CITY OF RIO RANCHO
DEPARTMENT OF FINANCIAL SERVICES
PURCHASING DIVISION
3200 CIVIC CENTER CIRCLE NE 3rd FLOOR
RIO RANCHO, NEW MEXICO 87144
TELEPHONE: 505-891-5044 FAX: 505-891-5762

ADDENDUM NO (2) TWO
IFB 17-PW-002
HIGH RESORT BOULEVARD RECONSTRUCTION

October 13, 2016

A1 CONNECTION DETAIL
1 : 10

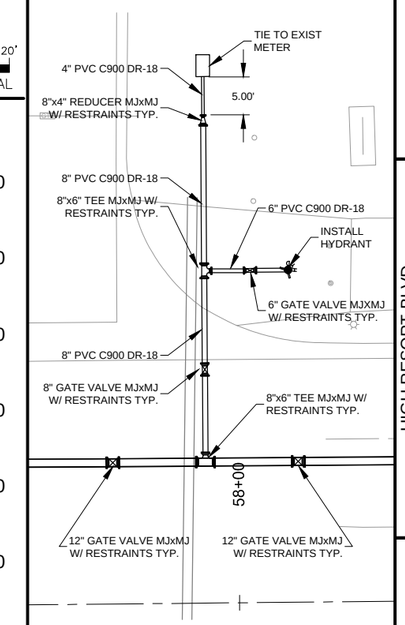
46. **QUESTION:** Plan Sheet 11-7, Detail A1 shows a Tie to Existing Meter (4"), and sheet 11-18 calls out: Install 4" Recycled Water Service Meter (Dtl sheet 11-25). Where will these items be paid? Detail W-06 sheet 11-25 makes no provisions for 4" lines, please provide pertinent detail for a 4" Recycled Water Service Meter.

ANSWER: No meter will be installed at this location, contractor to provide a 4" stub with gate valve and cap. See Revised Sheet and updated bid form for clarification.

C2 CONNECTION DETAIL 2 (STA 14+89.95)

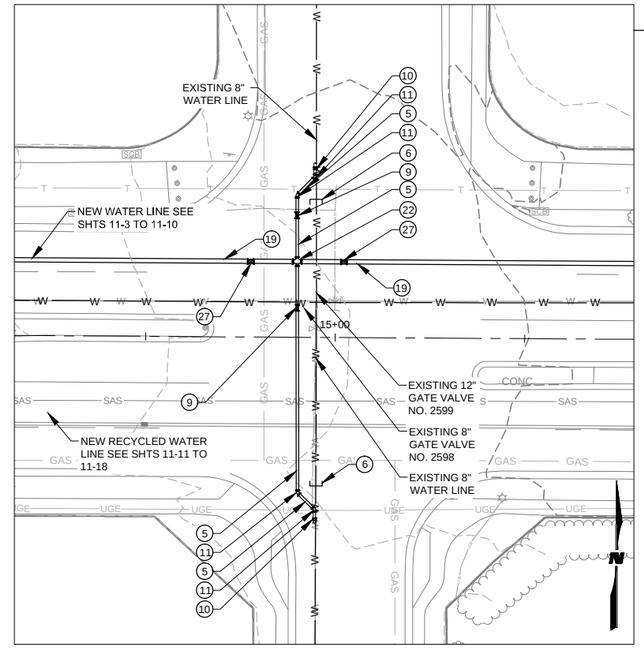
13. **QUESTION:** Starting the waterline connections, on sheet 11-19 C2, there Note 10 has a coupling connection to the existing 8" waterline from the new. Bid item 95 is for 12" Non-Pressure Connections. Can we have a bid item for 8" Non-Pressure Connections?

ANSWER: See updated bid form for added bid item.

C6 CONNECTION DETAIL 6 (STA 40+55.10)

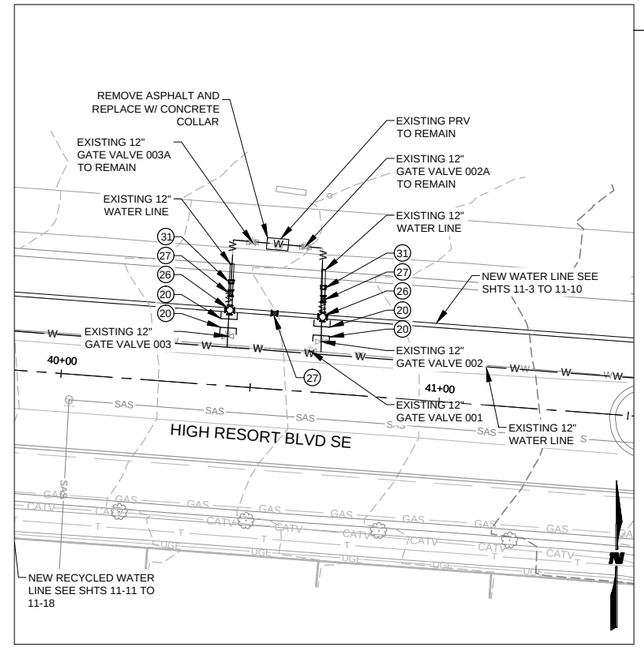
24. **QUESTION:** Plan Sheet 11-20, Detail 6 shows what looks like a Gate Valve on the Mainline between the Tees/Crosses for the PRV Assembly. Yet this Valve is NOT called out. Will this Valve be required?

ANSWER: Yes, See Revised Sheet for clarification.

C11 CONNECTION DETAIL 11 (STA 79+03.04)

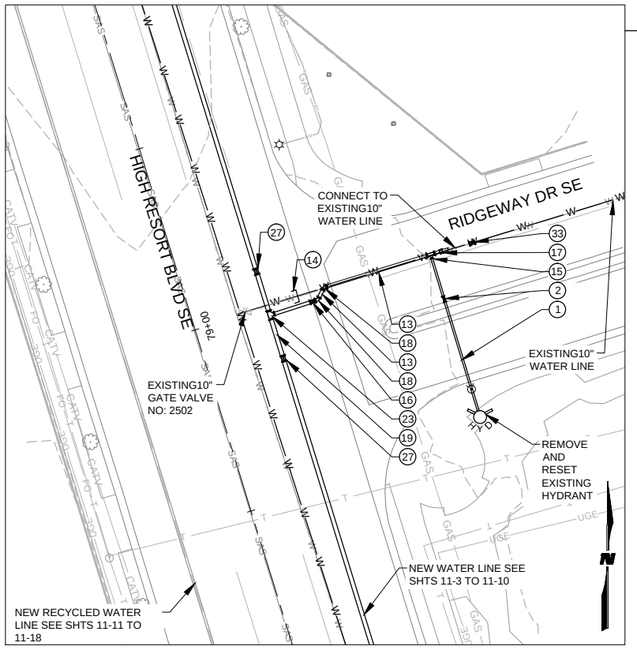
47. **QUESTION:** Bid Item #102 calls for 3 EA, 10" INSERTION VALVE: Only one is shown on sheet 11-21, detail C11. Please verify quantities in Bid Schedule.

ANSWER: The other two valves are to be installed near 4005 High Resort Blvd., City Project Manager will coordinate exact location with selected contractor to verify location of these valves.

C12 CONNECTION DETAIL 12 (STA 82+76.12)

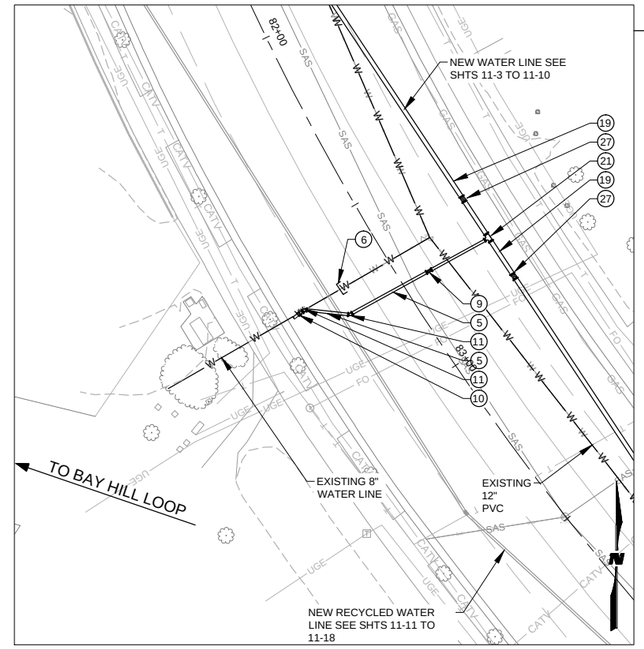
25. **QUESTION:** Plan Sheet 11-21, detail 12 has a Note #9 calling out an 8" Gate Valve yet no GV is shown on the line, please verify that a GV will be required.

ANSWER: Yes, See Revised Sheet for clarification.

C13 CONNECTION DETAIL 13 (STA 90+45.73)

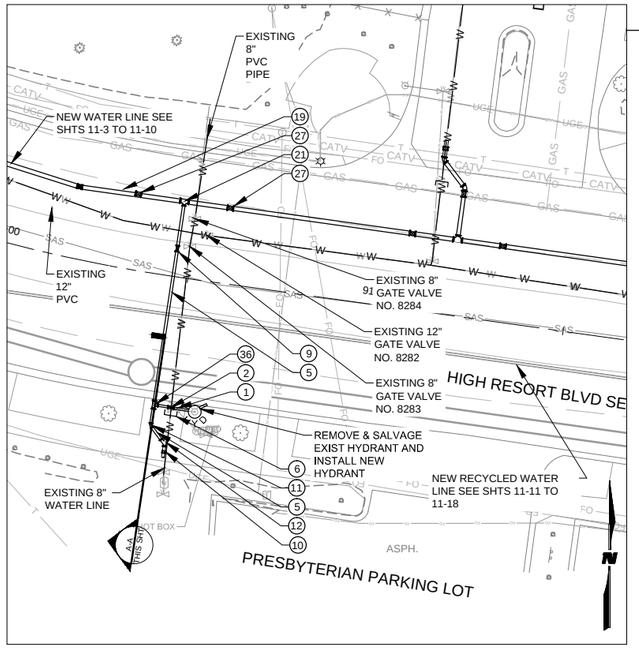
38. **QUESTION:** Bid Item #94 calls for 5 EA, FIRE HYDRANT, EXISTING, REMOVE & RESET, The Fire Hydrants shown on sheet 11-7 (Detail A-1) and sheet 11-22 (Detail C13) appear to be New FHs. Please confirm that this Item will include 2 ea New Fire Hydrants.

ANSWER: See updated bid form for added bid item.

C15 CONNECTION DETAIL 15 (STA 95+65.00)

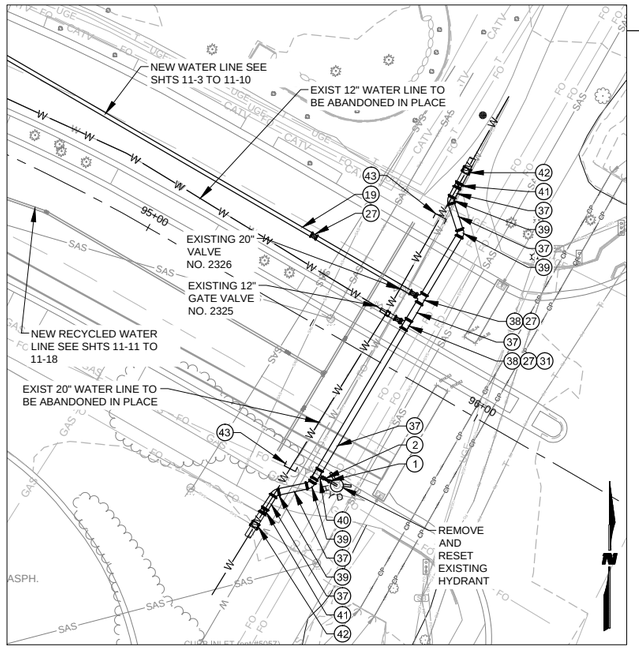
19. **QUESTION:** Plan Sheet 11-22, Keyed Note #43 calls for a 20” Tapping Saddle. Please clarify what this is. This looks like an Inline Connection, should this be a 20” Insertion Valve? If this is a “Tapping Saddle”, what size is the “Tap”? And what does it connect to?

20. **QUESTION:** Plan Sheet 11-22, Keyed Note #34 calls for a 20” Insertion Valve, yet this callout appears at what looks like a 20”x12” TEE. Please Verify this Callout. Is this the “Wet Tap” mentioned in note #2, Detail C15? Then, if that is the case would the 12” Gate Valve (note #27), which is shown to be about 30’ (scaled) away from the connection to the 20” be right at the Tap (Tapping Valve)?

21. **QUESTION:** Plan Sheet 11-22, Keyed Note #38 calls for 20” PVC Pipe, while Bid Item #90 calls 20” Ductile Iron Restrained Joint Pipe. Please clarify the type of pipe required at this location.

22. **QUESTION:** Plan Sheet 11-22, Keyed Note #41 calls for a 20"x6" Tapping Saddle for the Reset Fire Hydrant. As this 20" is a New line would a 20"x6" MJxMJ or MJxFL Tee work here in lieu of a "Tapping Saddle"?

36. **QUESTION:** Plan Sheet 11-22, Keyed Note #42 calls for 20" Gate Valve (MJxMJ), while Bid Item #91 calls for 20" BUTTERFLY VALVE. Please clarify the type of Valve required at this location.

ANSWER: 20” tapping saddle has been replaced with a 20”x20”x12” MJ tee and 12-inch gate valve, See Revised Sheet for clarification.

ANSWER: 20” insertion valve has been removed, wet tap mentioned in note #2, Detail C15 has been removed, 20” tapping saddle has been replaced with a 20”x20”x12” MJ tee and 12-inch gate valve See Revised Sheet for clarification.

ANSWER: New 20" pipe shall be ductile iron, See Revised Sheet for clarification.

ANSWER: 20"x6" Tapping Saddle has been replaced with a 20"x6" MJxMJ Tee. See Revised Sheet for clarification.

ANSWER: 20" valve shall be butterfly valves, See Revised Sheet for clarification.

C16 RECYCLED WATER CONNECTION DETAIL 16 (STA 58+00.00)

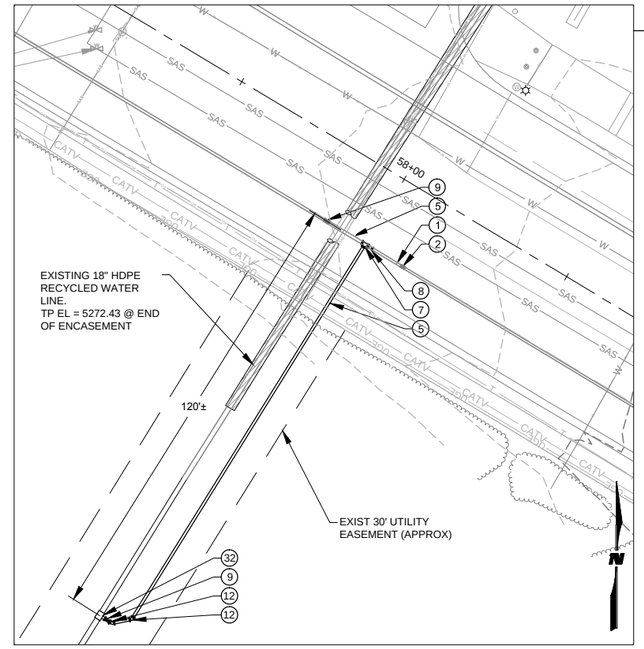
65. **QUESTION:** No bid item for the 18x8 tapping saddle for the re-use waterline connection per SH#11-22 detail C16.

SHEET 11-25

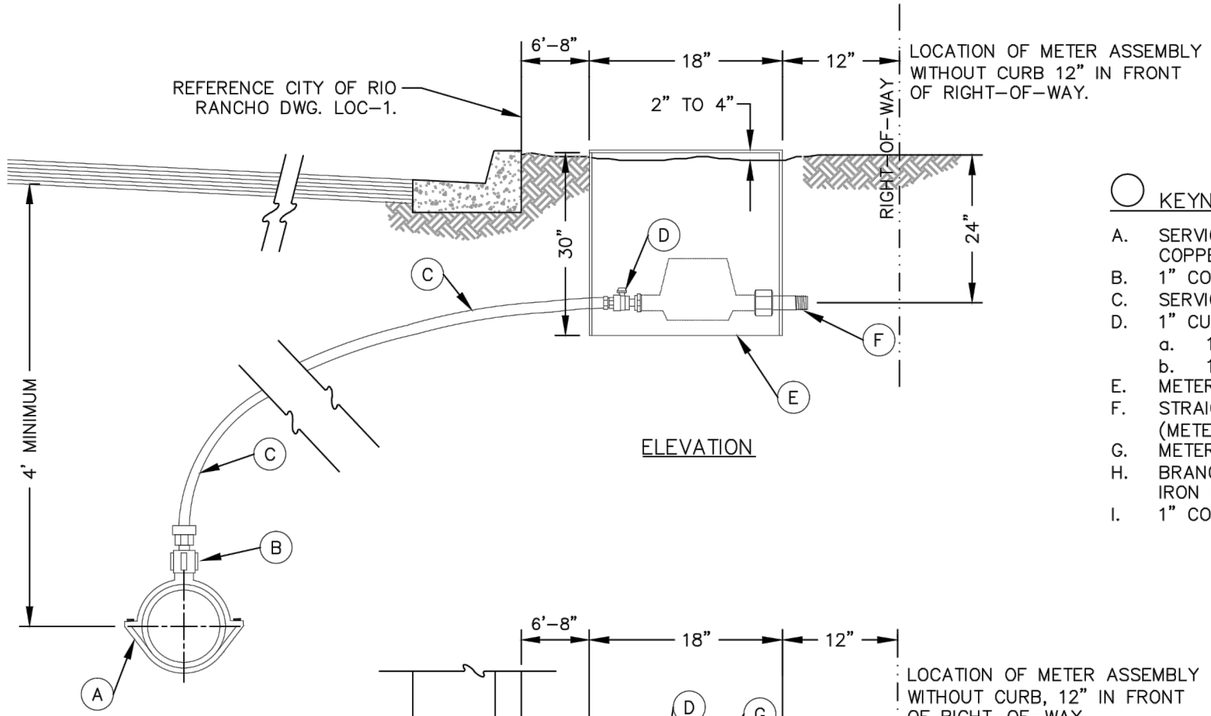
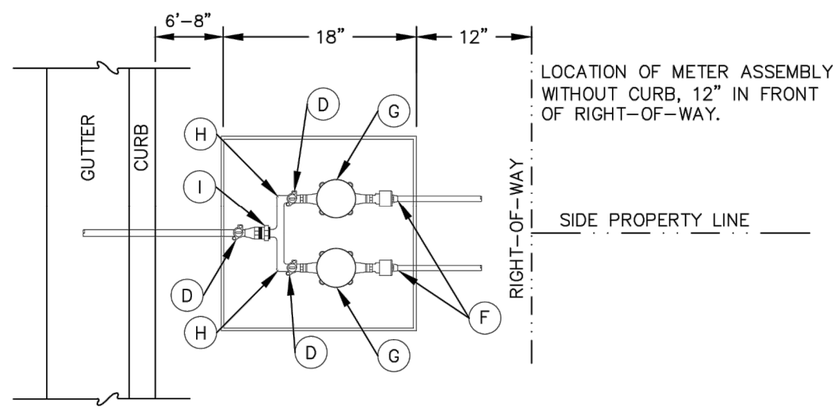
44. **QUESTION:** Please that Per detail sheet 11-25, a 5/8" service will require 1" copper line.

ANSWER: Service to be installed per CoRR Std. Drawing W-6.
